**Mineral Joe Mine Permit Amendment
Permit File No. M-1977-284**

Response to Adequacy Review

February 2013

Mineral Joe Mine, File No. M-1977-284, Amendment (AMI) Application Adequacy Review

Mineral Joe Mine Portal/Vent Hole

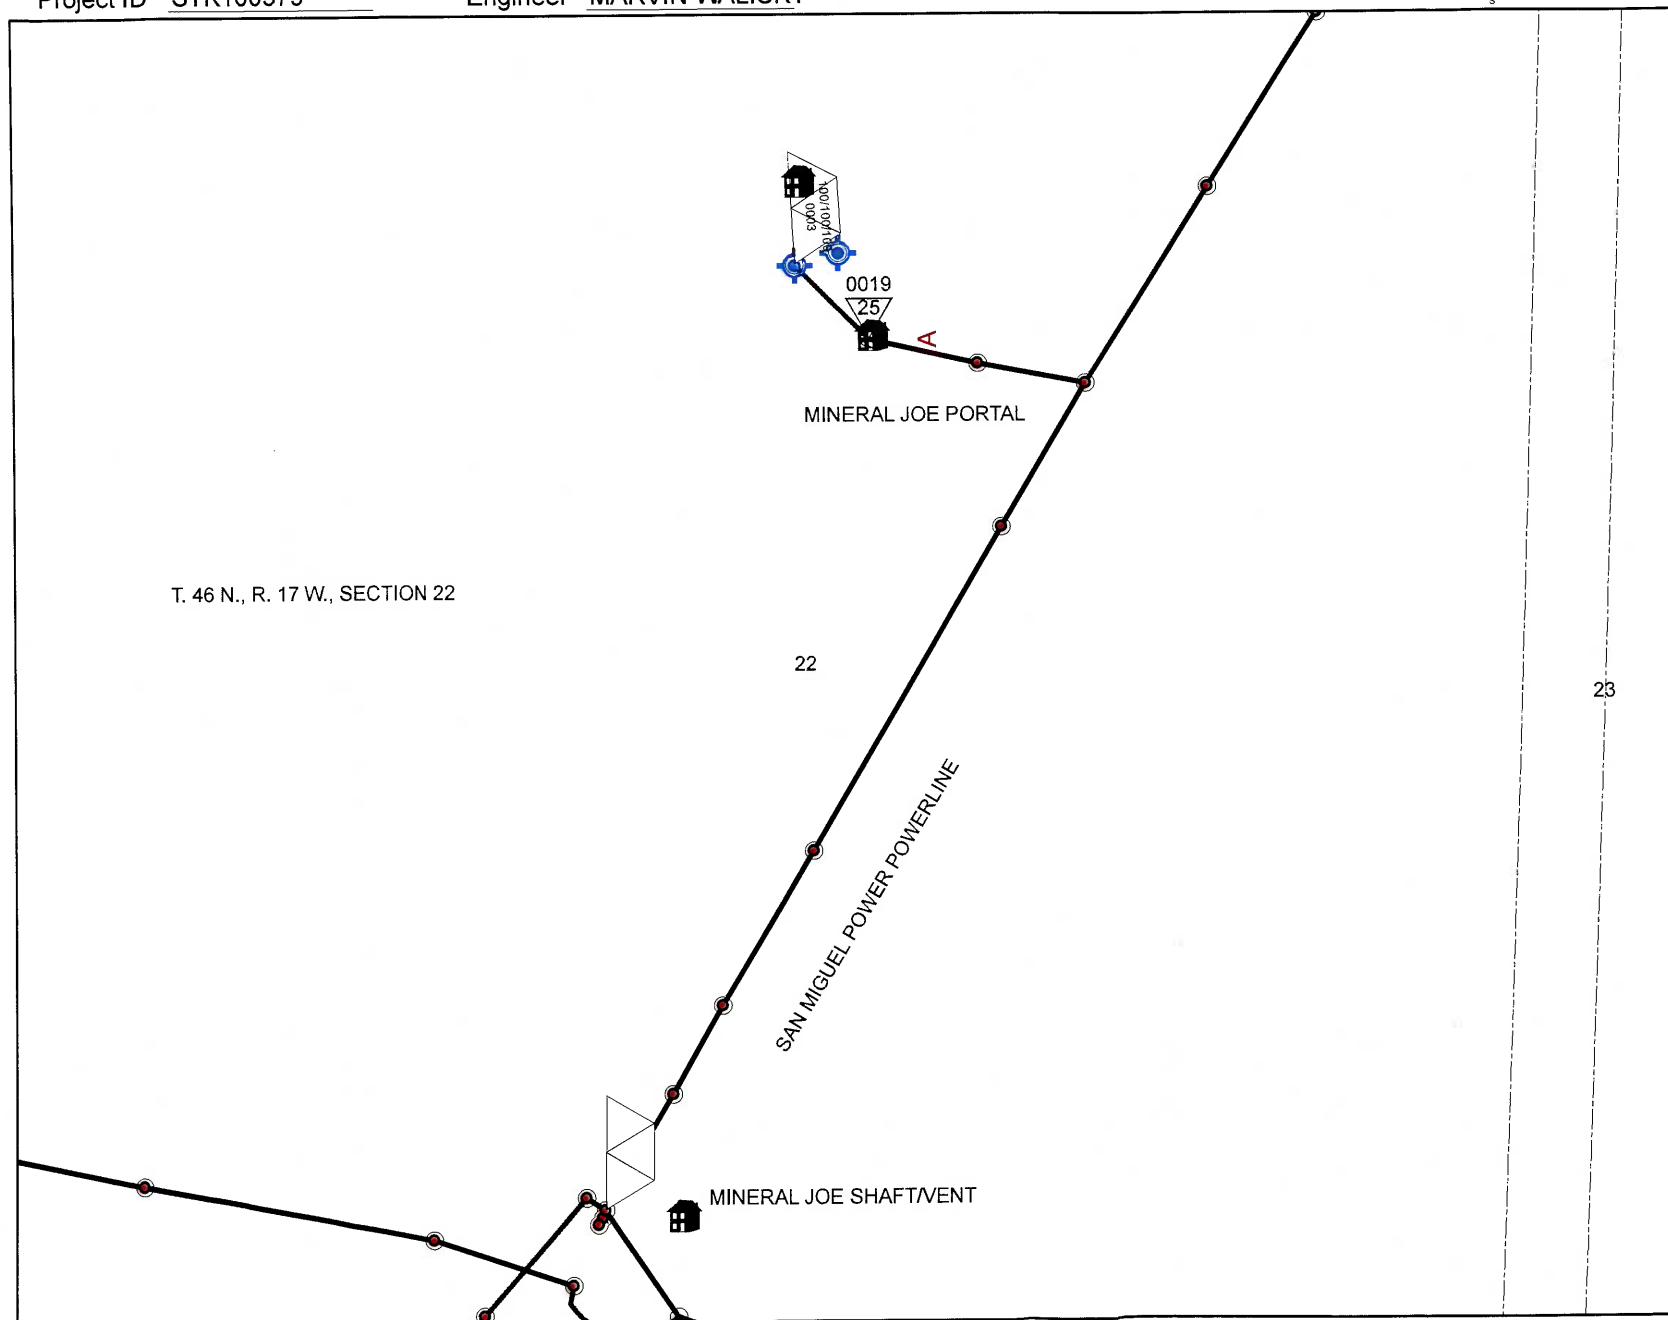
3. *Addressing Rule 6.3.12 - The mine plan proposes to utilize power supplied by a San Miguel Power Association. Please submit to the Division, either a notarized agreement between Cotter Corp. and SMPA, that Cotter Corp. is to provide compensation for any damage to the power line caused by the mining operation, or a notarized letter, from SMPA on their letterhead, that the proposed mining and reclamation activities will have "no negative effect" on their power line.*

A copy of the agreement between Cotter Corporation and SMPA is included in Attachment 1

RADIOMETRIC SURVEYS

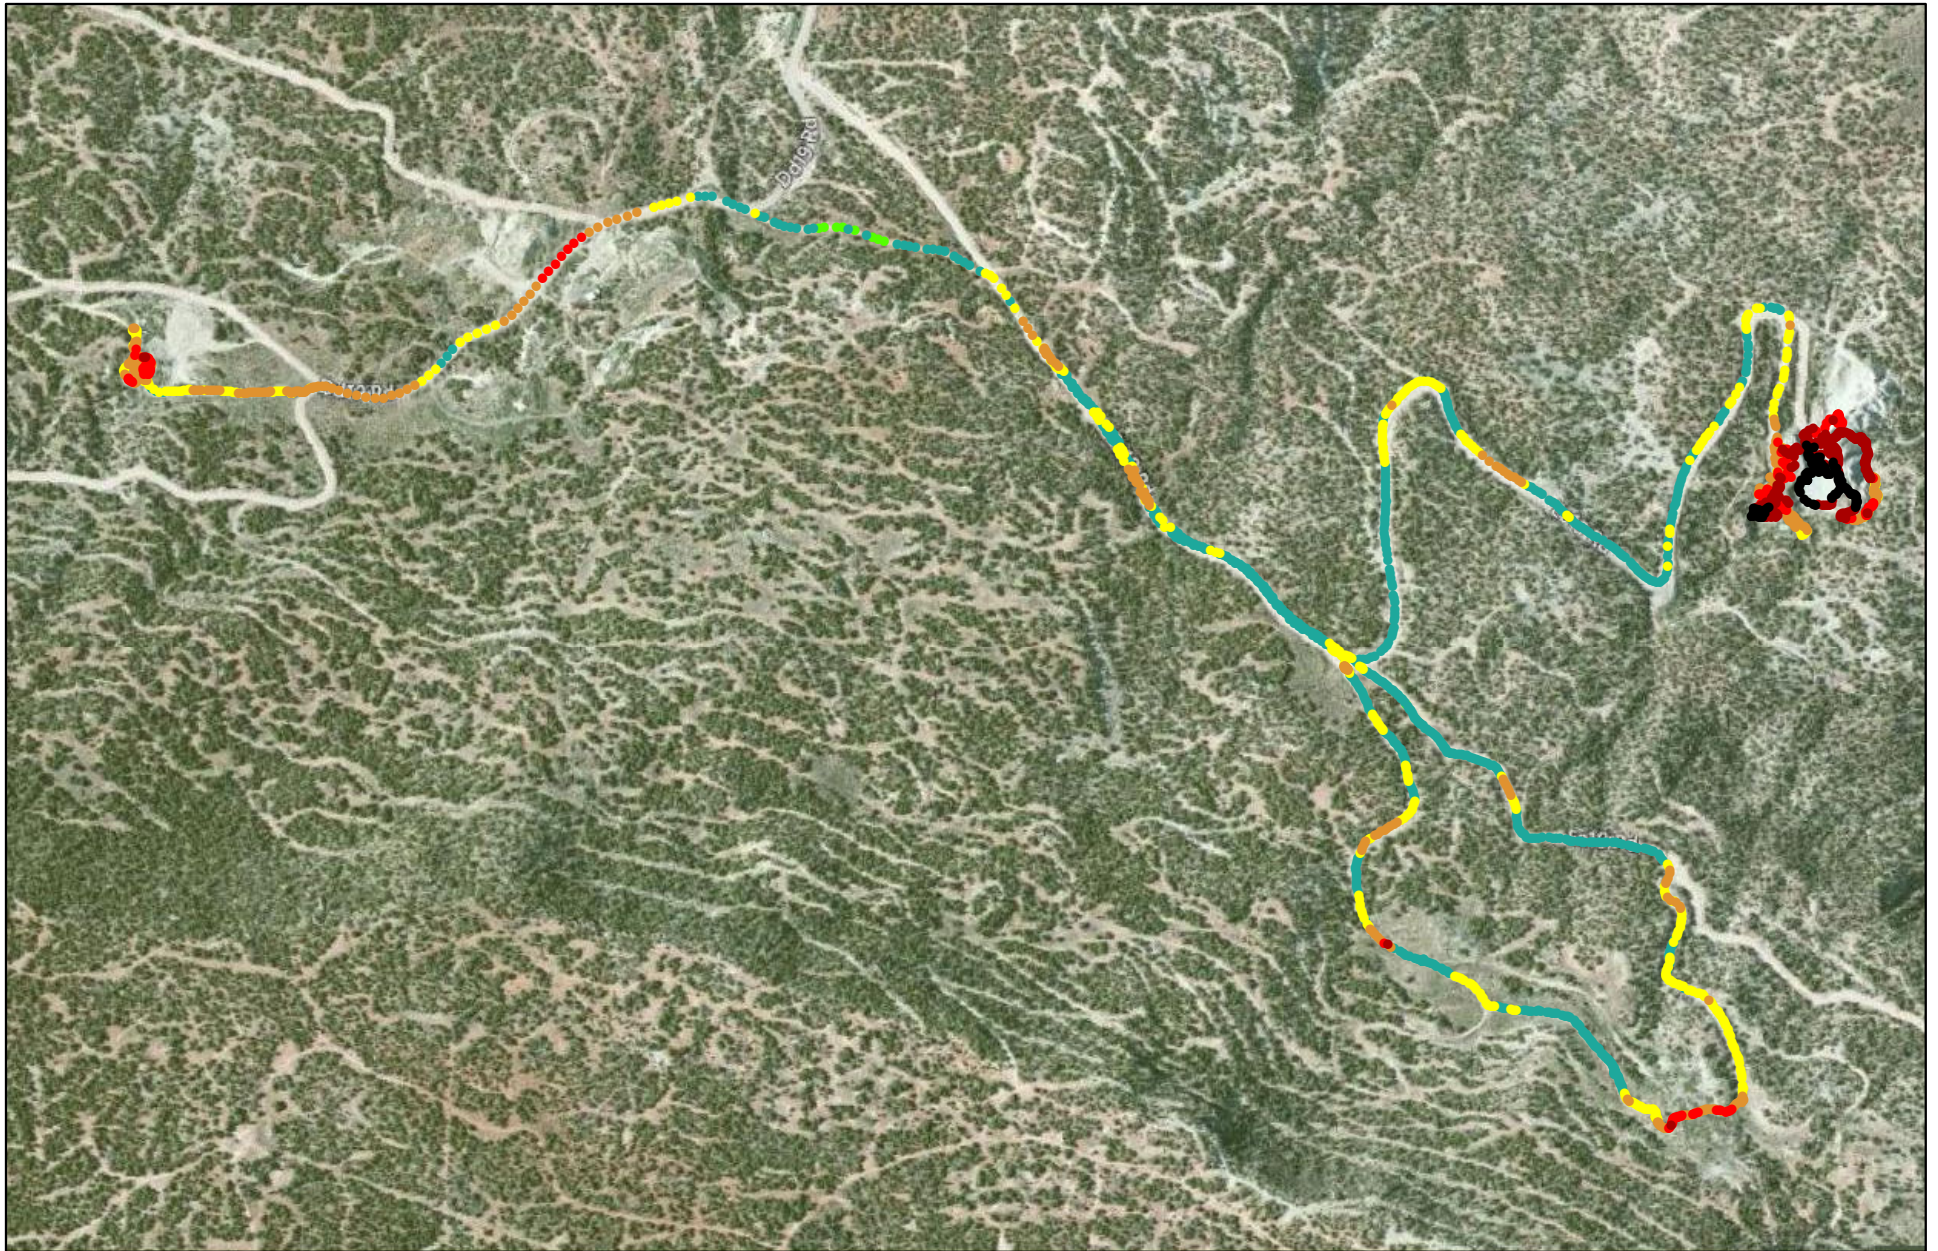
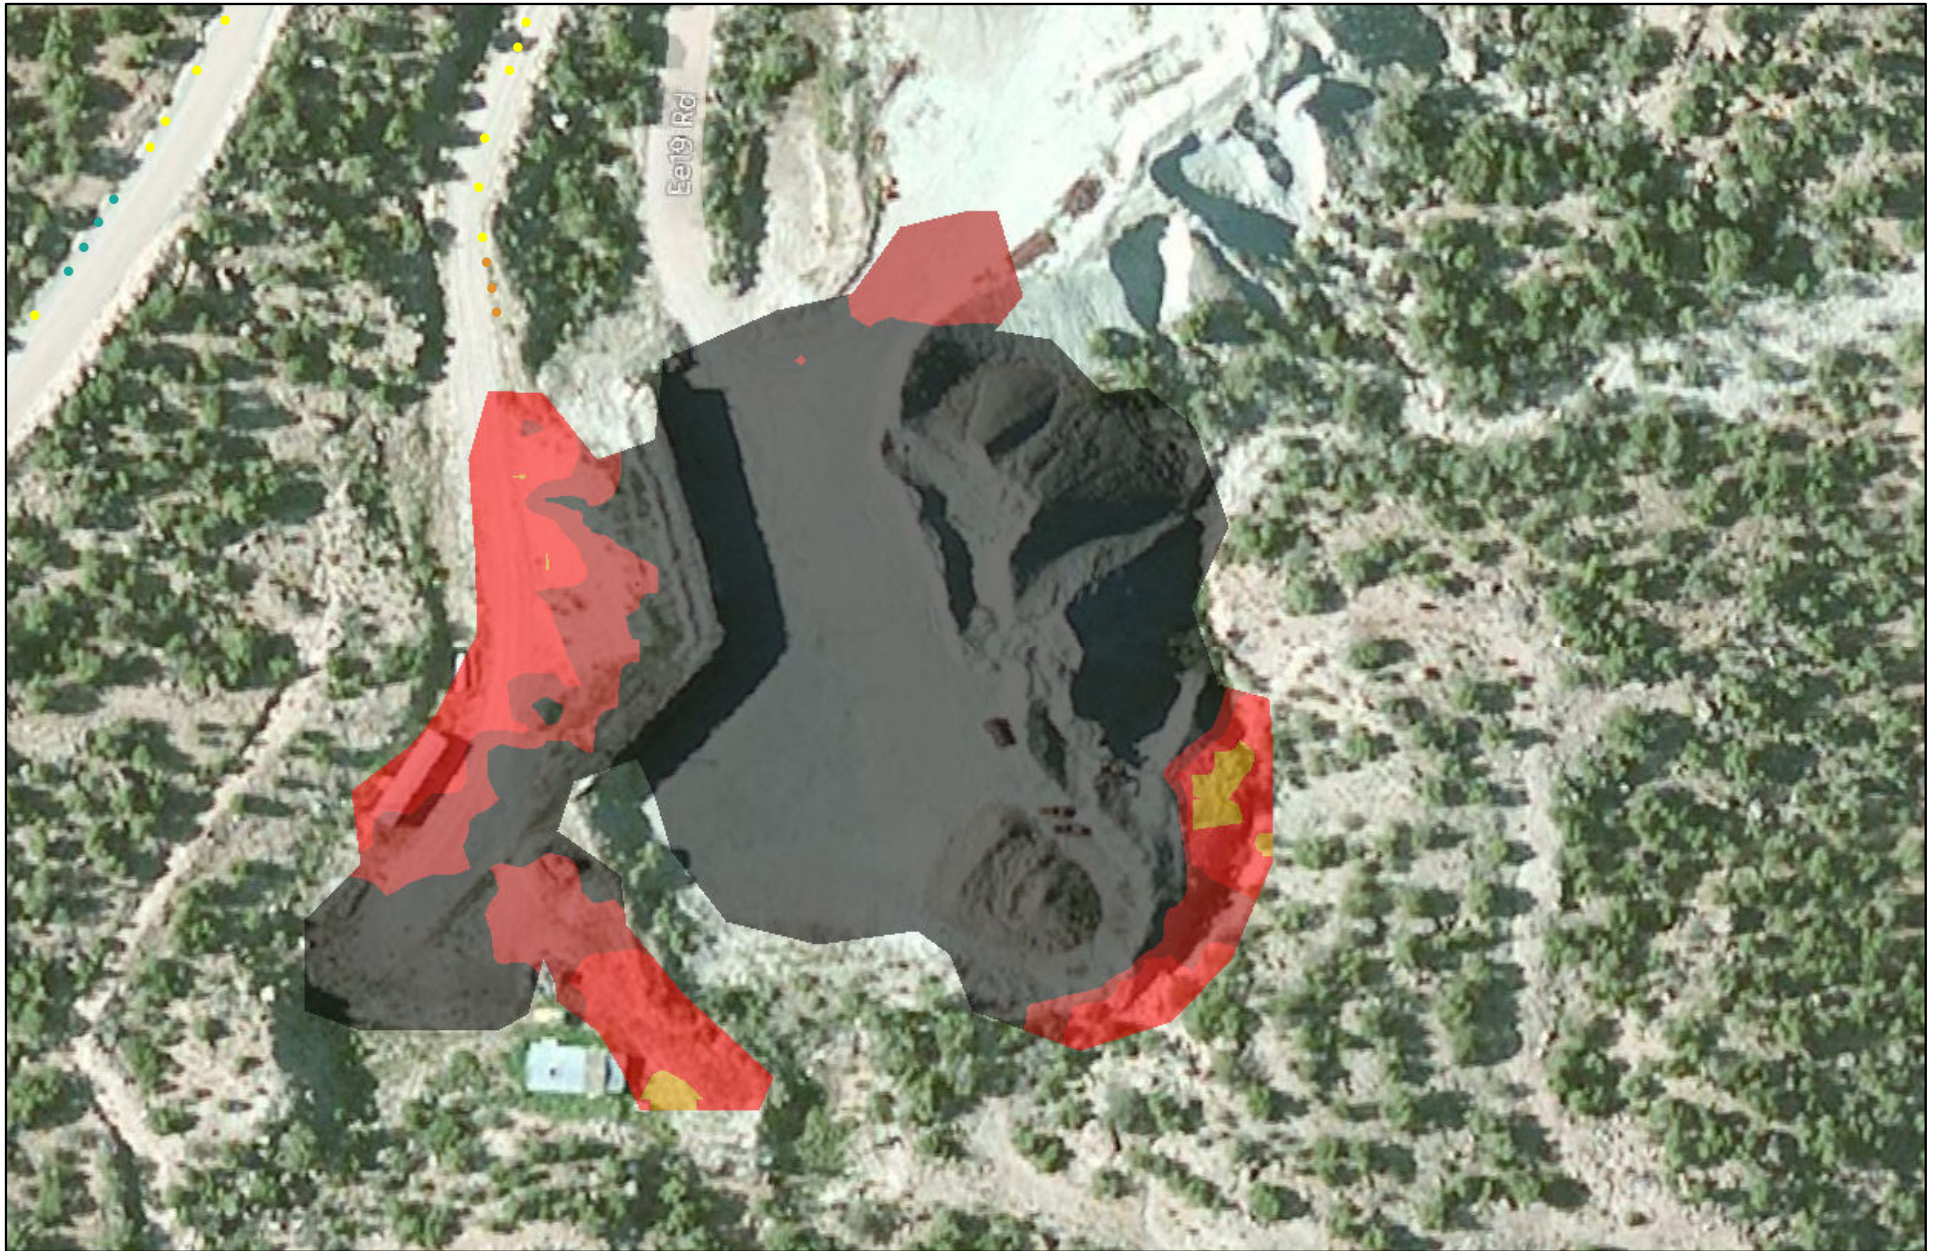
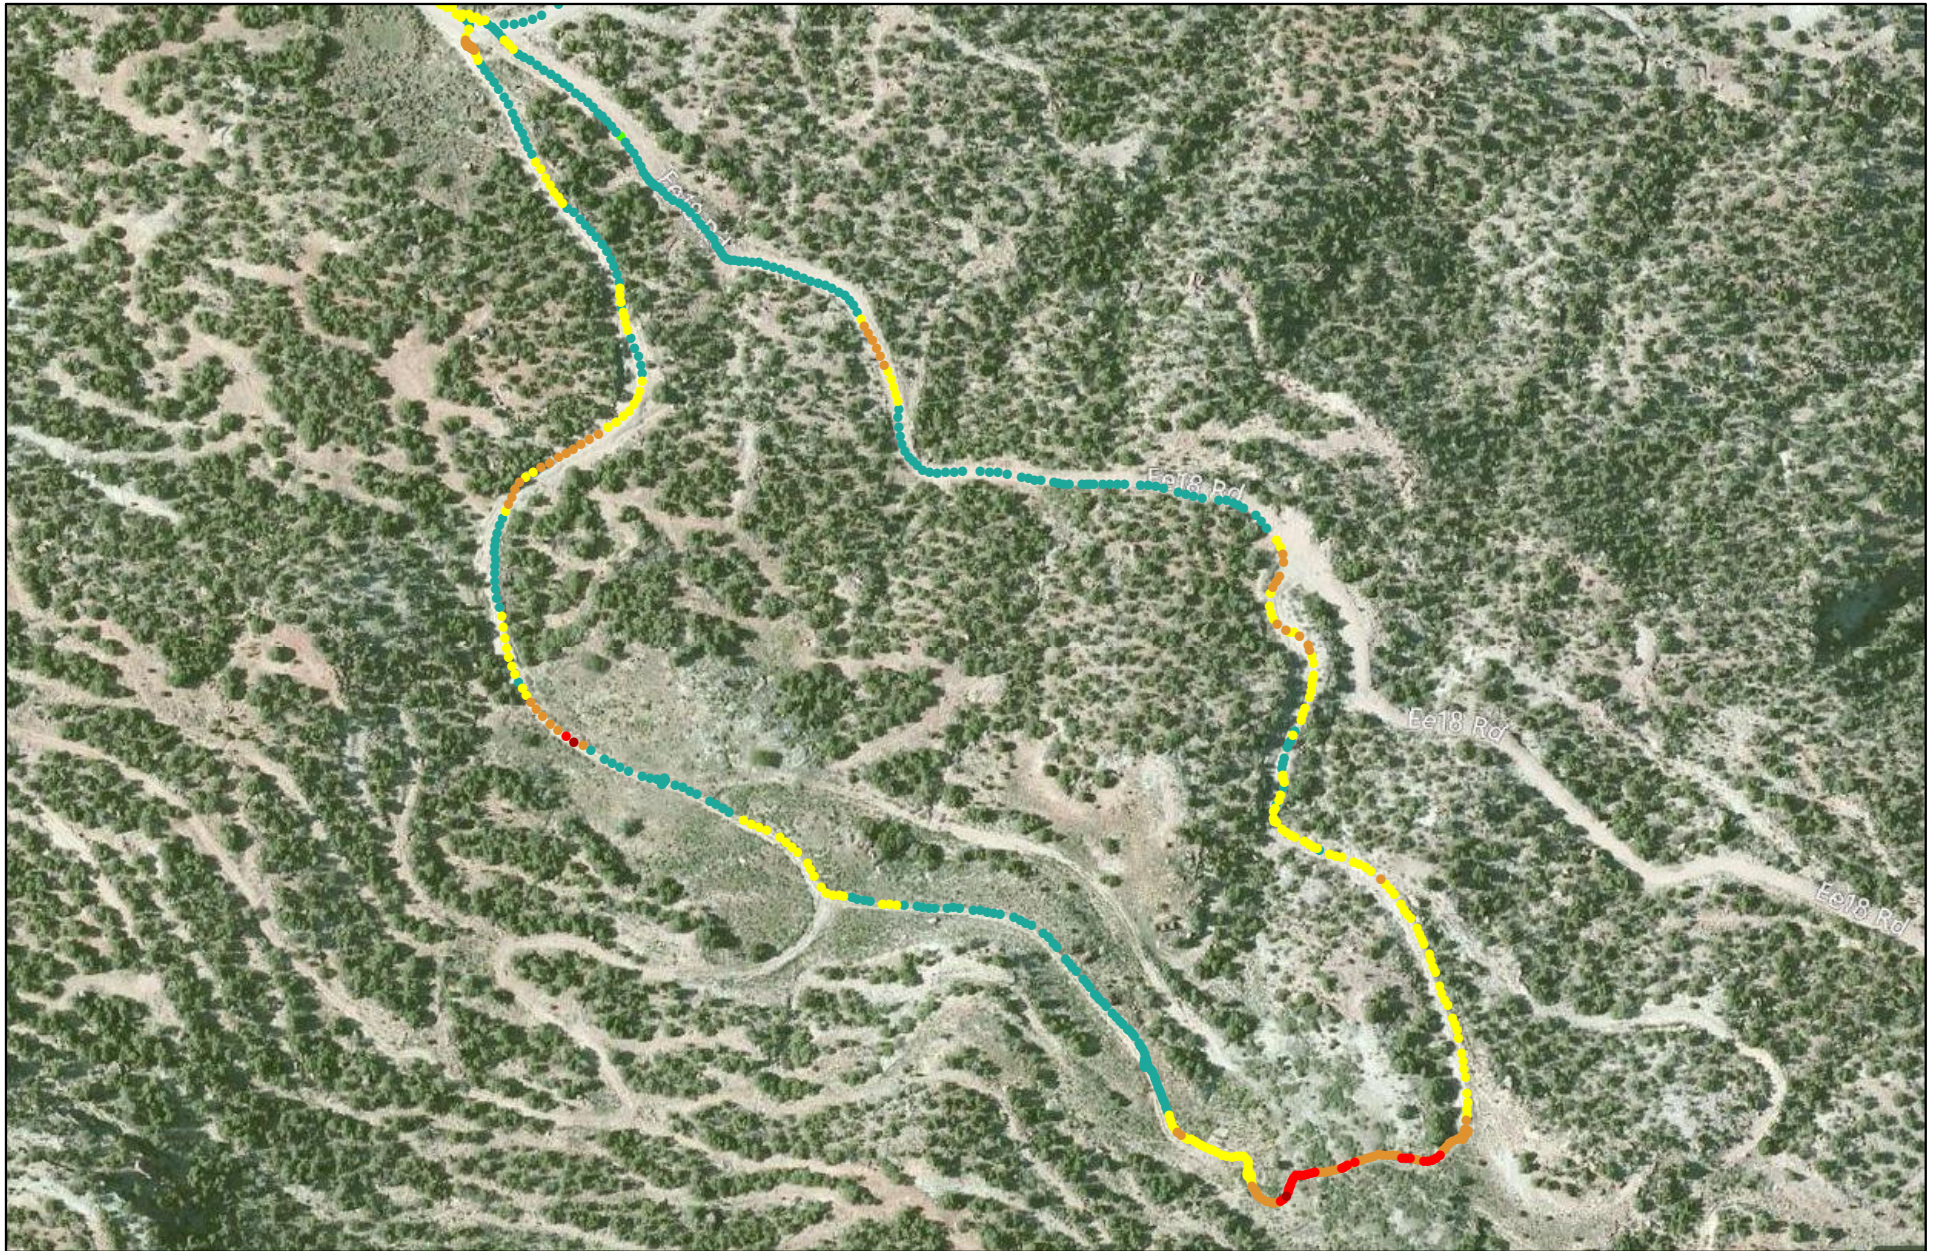
4. *Addressing Rule 6.4.21 (7) - The EPP states that a radiometric survey will be completed prior to mining in order to document baseline conditions at the site. Baseline conditions shall be established as part of this amendment process. Please conduct a radiometric survey of the affected area and submit the results to the Division along with an evaluation of the expected effectiveness of the proposed EPP, which specifically addresses the risks, from uranium, uranium byproducts, and any other radionuclides expected to be encountered during this operation, to human health, property and the environment.*

The baseline radiometric survey is included as Attachment 2 in this response to DRMS comments. Cotter procedures for separating ore from waste rock are designed to minimize the addition of uranium ore to the waste rock pile—an approach that makes sense from an economic and environmental standpoint. The EPP addressed several issues that evaluate the risks to human health and the environment. The potential of acid mine drainage from the waste rock piles was quantified by the Acid-Base Accounting tests that indicated this was not an issue. Section 5.4.1.8 of the EPP discusses the SPLP results for uranium for the Mineral Joe waste rock which are below the drinking water standards. In this section the high potential for
